**NOTICE OF  
COUNCIL ASSESSMENT PANEL MEETING**

**CITY OF MARION  
COUNCIL ASSESSMENT PANEL AGENDA  
FOR MEETING TO BE HELD ON  
WEDNESDAY 01 FEBRUARY 2023  
COMMENCING AT 6.30PM**

**4.1 DEVELOPMENT NO 22034359**

**4.2 DEVELOPMENT NO 22020483**

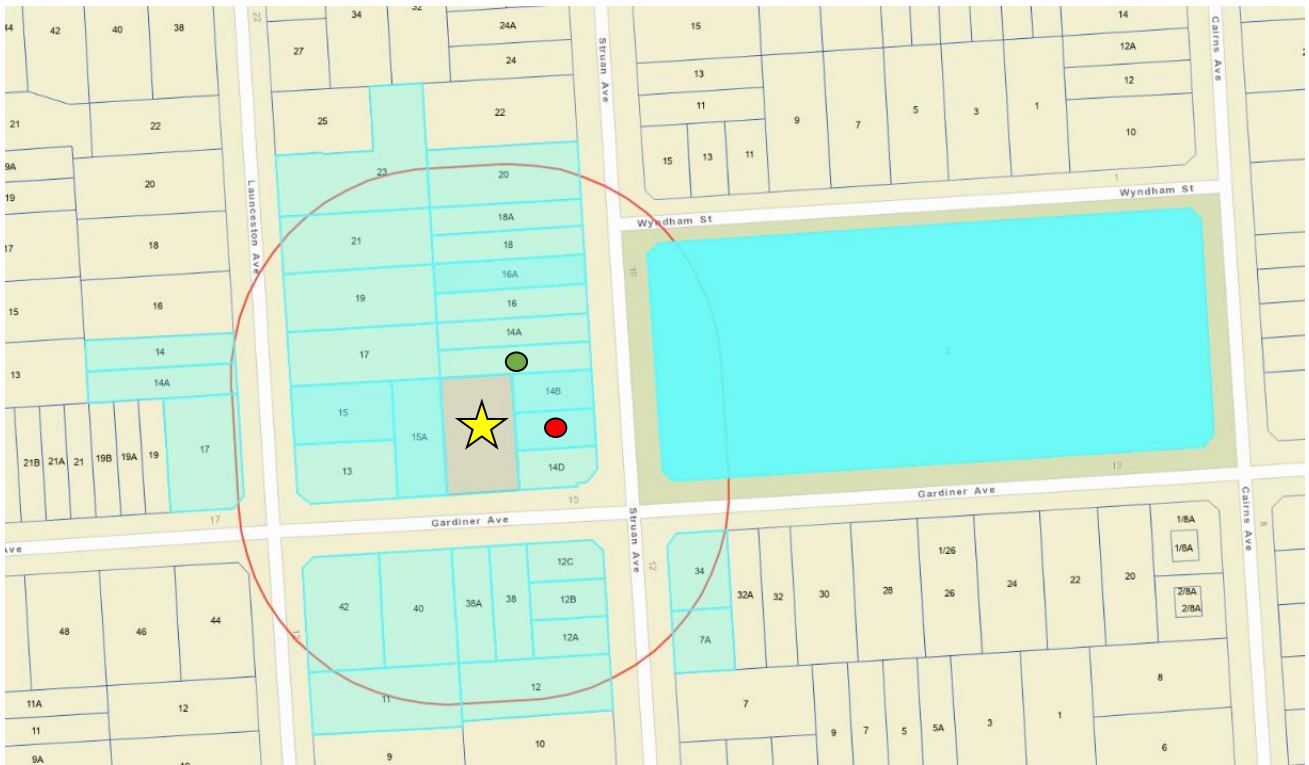
The proposal incorporates a wall height exceeding 3 metres from the footings upon the eastern boundary; and the proposal's maximum building height is 9.52 metres. Dwellings are not excluded from Notification where the building height exceeds the maximum of 9 metres sought by Zone DTS/DPF 4.1, or where the height of a boundary wall exceeds 3 metres in height from the footings of the dwelling.

After public notification concluded, the applicant has made amendments to decrease the height of the proposed boundary wall from 3.44 to 2.7 metres from footings for most of its length.

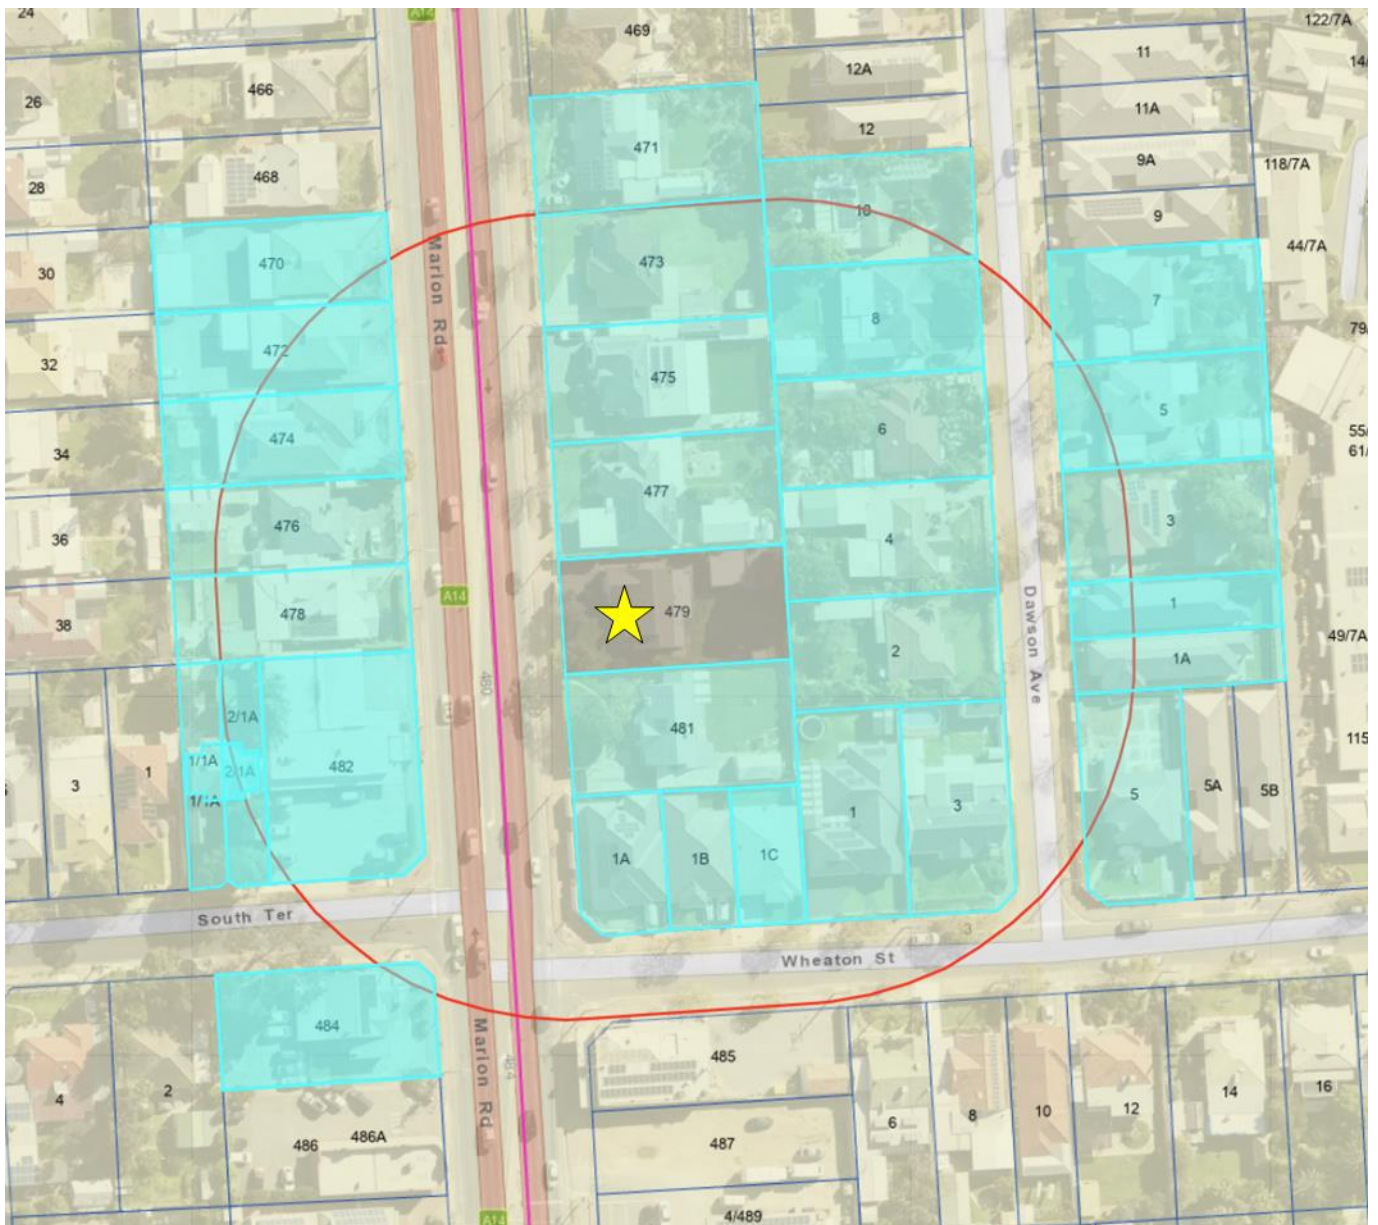
Council's Development Engineer has reviewed the supplied traffic engineer's documentation and is satisfied in respect to the demonstrated vehicle manoeuvring.

Council's Arborist has reviewed the proposed conflict with the existing street tree, and has advised that street tree retention is preferred. The Arborist recommended the applicant consider alternative vehicle access methods, which have not been implemented.
